CITY OF CAMBRIDGE - BOARD OF ZONING APPEAL

LOCATION OF PROPERTY:  Gund Hall, 48 Quincy Street

The Harvard Graduate School of Design seeks variances for the number, area and illumination of new exterior building signage.

Article  7  Section  7.16.21.B, number, area, and illumination of signs

**Sign 1 - Wall sign for building identification, on south elevation**

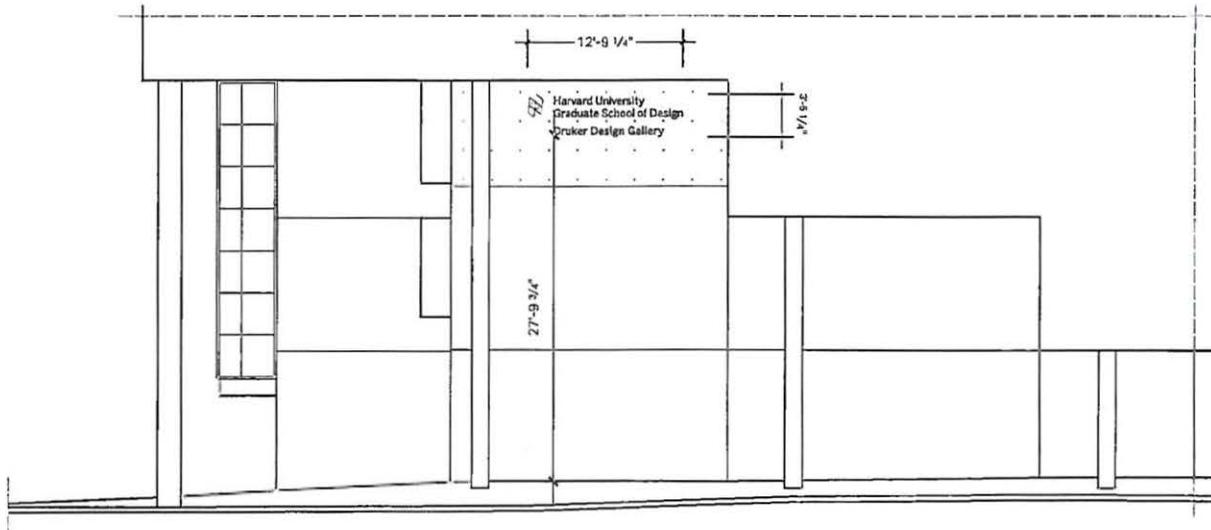
COMMENTS: exceeds size limit for wall sign  
exceeds total signage for building  
exceeds height for sign > 4 ft

**Sign 2 - Wall sign for building identification, in south entry way**  
24' from public way in a dark, recessed portico space

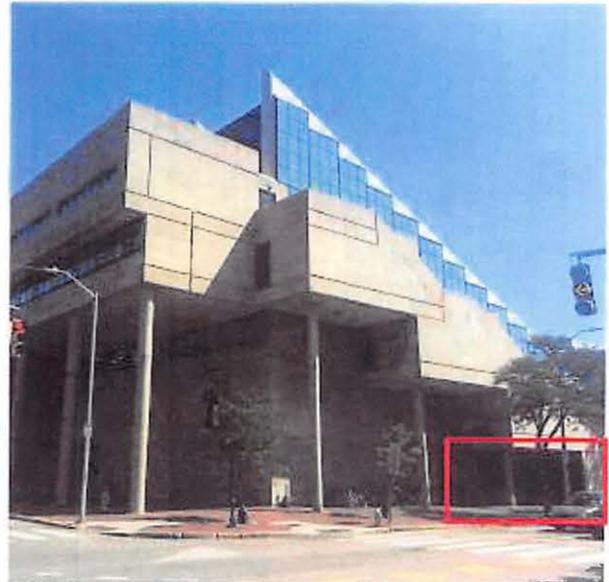
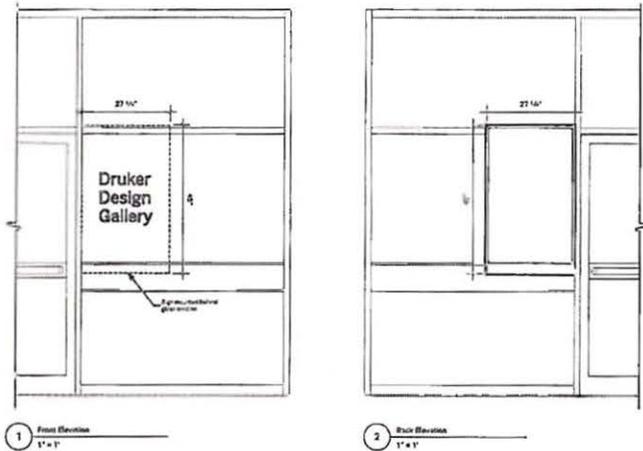
COMMENTS: Natural or external illumination only in Res. Districts

**Sign 6 - New sign in west portico**

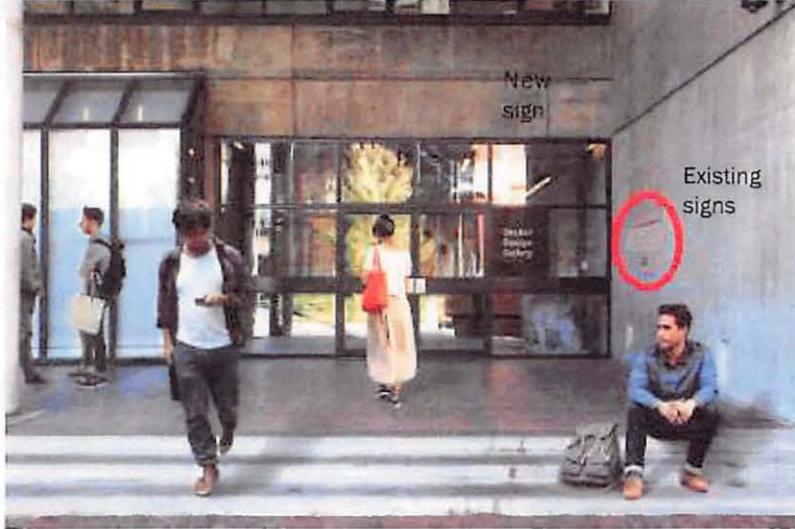
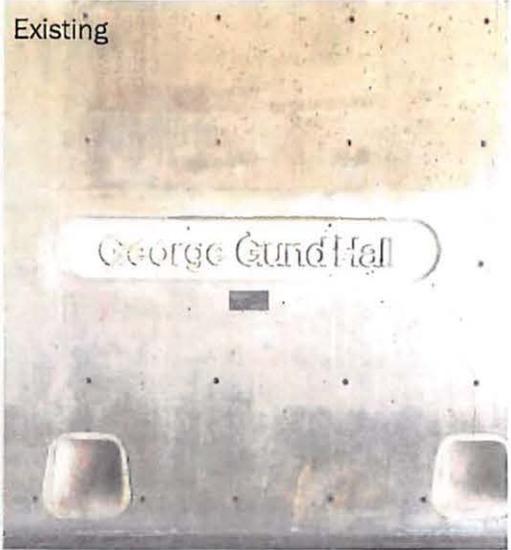
COMMENTS: Natural or external illumination only in Res. Districts

**Sign 1 - Wall sign for building identification, on south elevation**

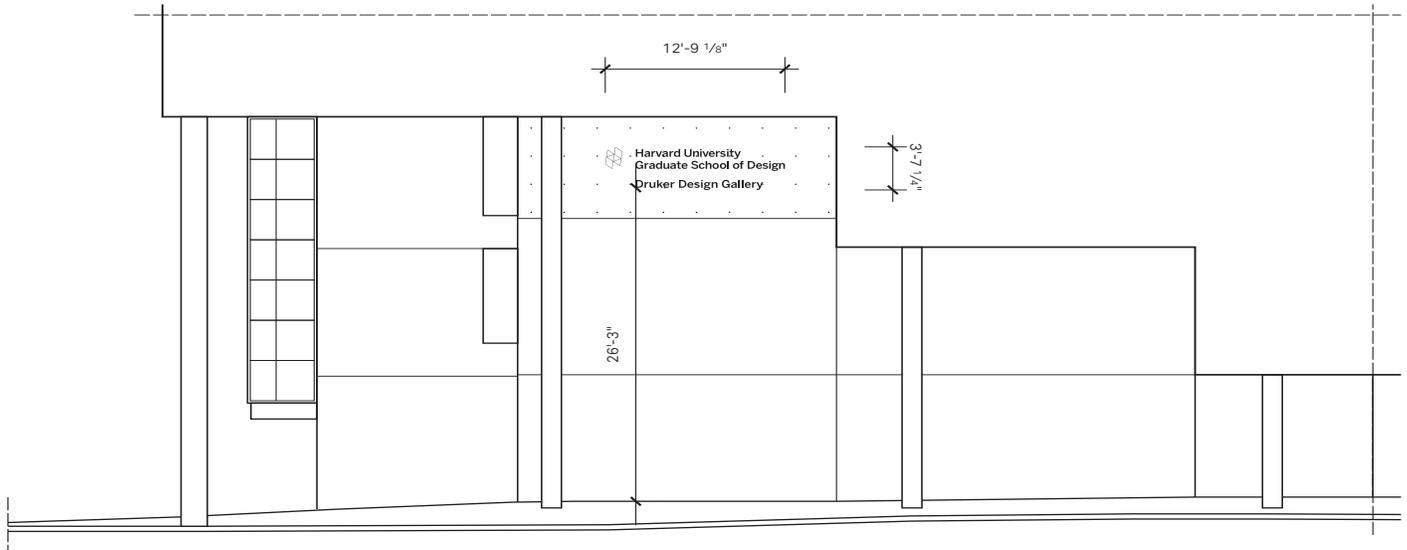
Variance required for sign area (20 SF max allowed); number of signs - 3 instead of maximum of 2
